赴加拿大 Candu 公司及美國
Sargent&Lundy 公司參訪

服務機關：核能研究所

S&L GSI-191 Work for Maanshan

Maanshan GSI-191 Meeting

#2: Temp-Mat ZOI

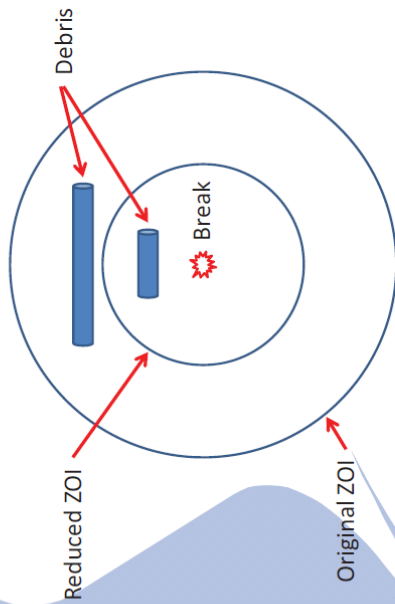
#2: Temp-Mat ZOI

- Similar argument to mineral wool
- Assumes that Temp-Mat cassettes cannot be longer than 6" at MNPP

Cassettes Appear > 6"

Figure II-2. LDFG Damage Curve for Small Fine Debris

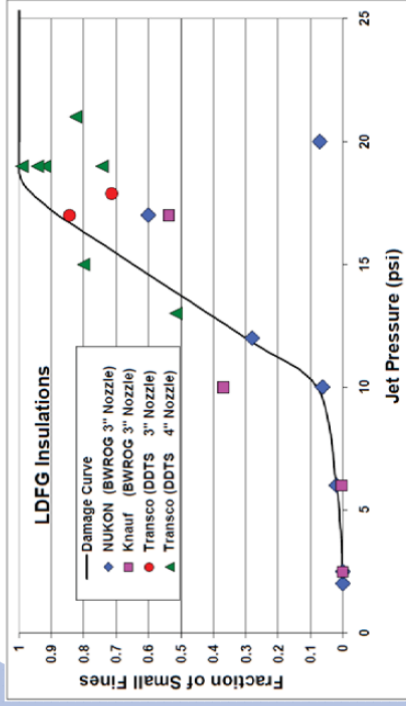
#3: Temp-Mat Size Distribution

- Upstream Assessment Open Item
 - MNPP-34325-ASD-002
- Temp-Mat size distribution
 - 60% small fines
 - 40% large pieces
- Size distribution intended to be used with NRC SE Temp-Mat ZOI of 11.7D
- Not appropriate when using a reduced ZOI

#3: Temp-Mat Size Distribution

- Excerpt from NRC guidance (ML100900172) for use of Sure-Hold bands with Nukon (which reduce the ZOI):
 - Appendix II documents that the staff's acceptance of the **baseline size distribution of 60% small pieces and 40% large pieces for Nukon fiber blankets was based on a ZOI size of 17D**. As demonstrated in Figure II-2 from this appendix, the **degree of insulation fragmentation is not constant with jet pressure**, but increases as the jet pressure impacting the target is increased, approaching 100% fragmentation into small fines at impingement pressures of approximately 20 psig.
- Same concept applies to Temp-Mat

Figure 3.2 - Schematic of Array of Modules Connected to Common in-Floor Plenum

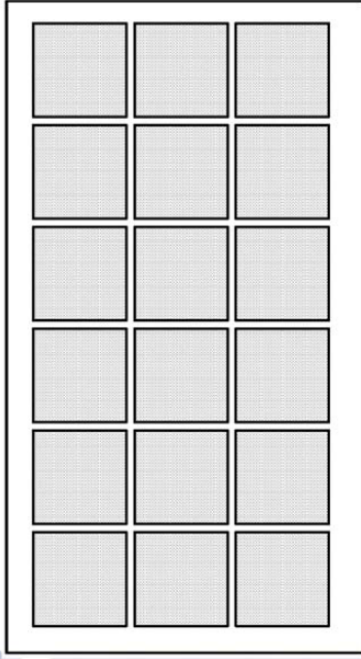
- Condition not fully dispositioned in current documentation
 - Need to explain how testing demonstrates that plant will not experience circumscribed debris condition
 - Perimeter fins in the plant will be exposed to ~4 times the tested debris load
- Some justification was provided in comment responses, but not in design documents

- From March 2008 NRC head loss test guidance
 - Figure 3.2 schematically shows modules connected into a common plenum with the modules arranged in an array. In this type of arrangement, the center modules may only have one outer surface contributing to the circumscribed area. During prototype testing of a single module, it is unlikely that the similitude for both the screen and the circumscribed velocities can be simulated simultaneously. For these strainers, the test matrix may have to include tests where the respective similitude is achieved piecemeal. A simple area-ratio scaled head loss test may not be conservative.

Figure 6-21 MNPP-CET01 Total Nitric Acid Added and Measured pH Upstream of the Strainer Box

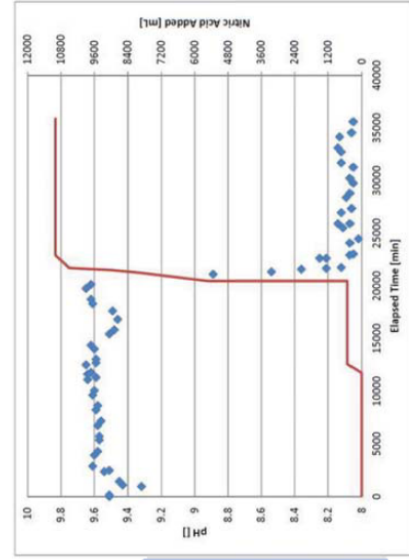
- Test Report Open Item
 - MNPP-34325-TR-001
- Lowest tested pH ~8.1
- Test acceptance criterion was pH 8.0±0.2
 - Comment made prior to test suggested pH acceptance criterion of 8.0 +0/-0.2
- Higher pH values are non-conservative
- TPC was to look into actual minimum pH
 - Believed minimum pH ~8.5
